1992 - 1993 Corvette: Service Bulletin: Noisy/Fraying Accessory Drive Belt

Subject: NOISY/FRAYING ACCESSORY DRIVE BELT (INST. SINGLE-SIDED BELT)

Model and Year: 1992-93 CORVETTE WITH 5.7L (LT1) ENGINE

Bulletin Number: 93-273-6A

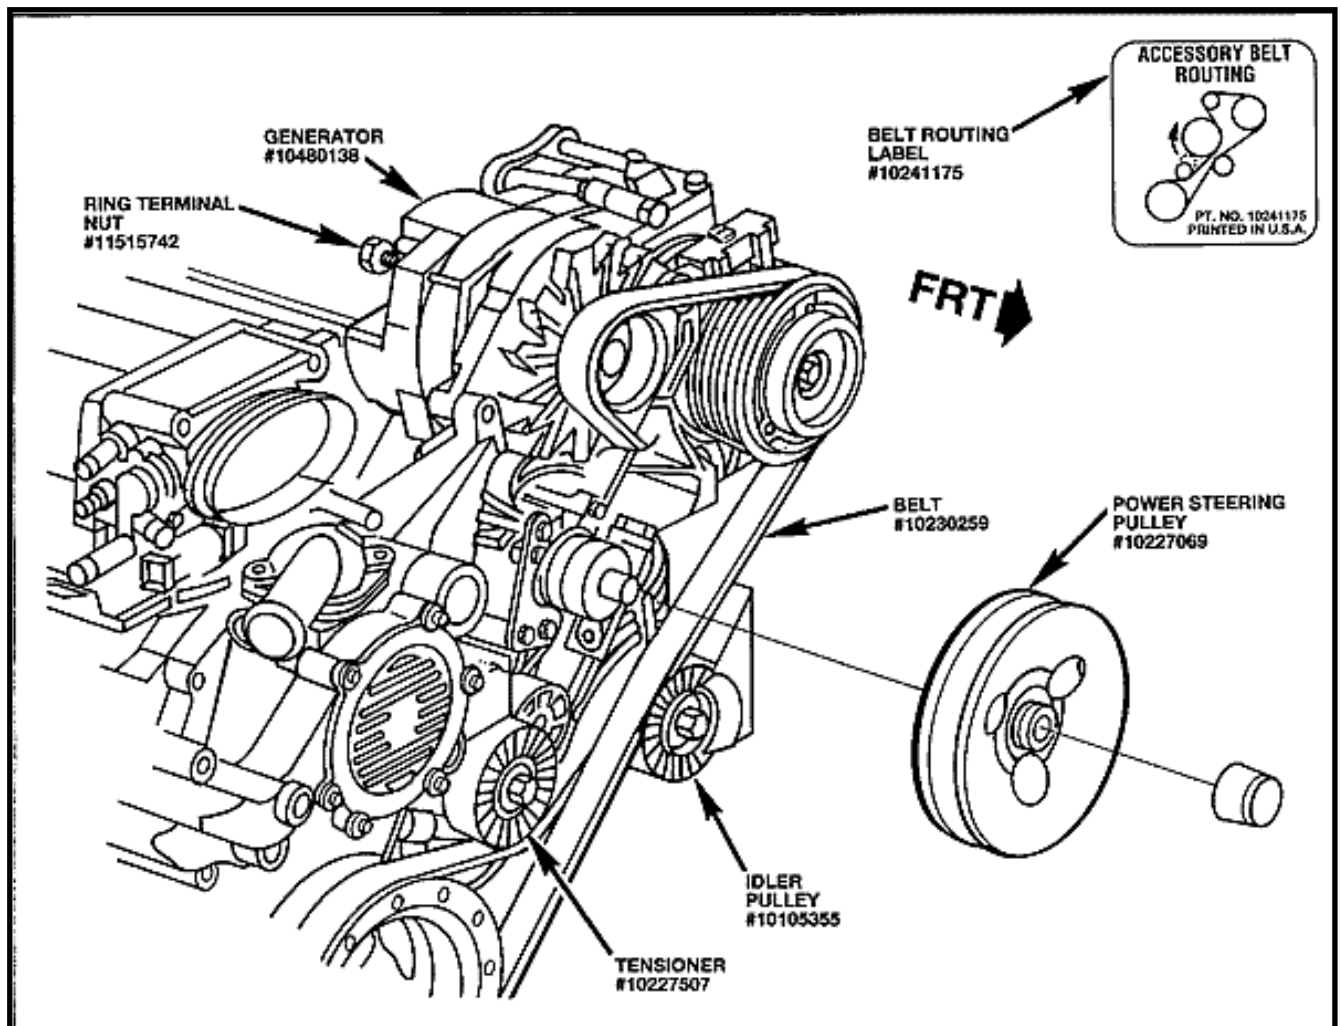
Some owners of 1992 and early 1993 model year Corvettes with 5.7L (LT1, VIN P) engines using the double-sided accessory drive belt may experience a noisy or fraying belt condition.

Inherent stresses and/or processing of the double-sided belt.

To correct this condition a change was made from the double-sided belt system to a new single-sided belt system. Starting the week of March 22,1993, VIN breakpoint #1G1YY23P4P5113150 Corvettes with LT1 engines were built with the new single-sided belt. To repair older units with the double-sided belt to a single-sided belt, the following parts must be installed:

10230259 Belt

10227507 Tensioner
10227069 P/S Pulley
10105355 Idler Pulley
10463533 Generator
11502811 Generator Ring Terminal Nut #M8

NOTE: When replacing the new generator, the ring terminal on the wire harness will have to be opened up the 8.5mm to accommodate the larger stud on the back of the new generator.
